Reference: Preliminary/Final Major Subdivision and Land Development Plan – Review #2
Breckenridge Towers Subdivision and Land Development Plan
Tax Map Parcel Numbers: 15-12-287, 15-12-288, 15-13-1

As requested, Gilmore & Associates, Inc. has reviewed the Preliminary/Final Major Subdivision and Land Development plan for Breckenridge Towers, dated January 7, 2024, last revised July 21, 2025, prepared by Carta Engineering for the applicant Collie Construction.

Mature trees are located on site. View of site from Breckenridge St.

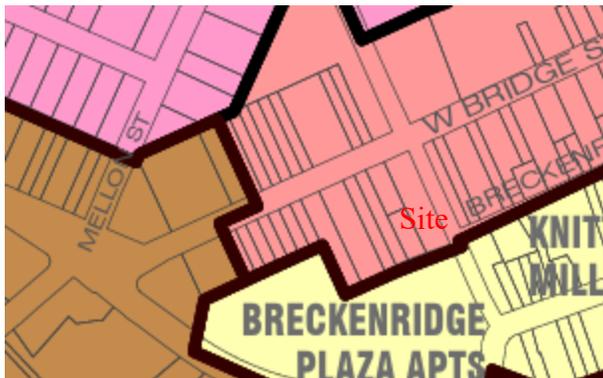
- ii. A site visit conducted February 26, 2025, revealed that there are multiple mature trees located on the site, which are not indicated on the plans. The plans should be revised to show the location and size of these trees.

- iii. The applicant is proposing to remove thirteen (13) mature trees with a total of two-hundred-thirty-six caliper-inches. We recommend the applicant provide replacement trees or a fee-in-lieu, at the Borough’s discretion.
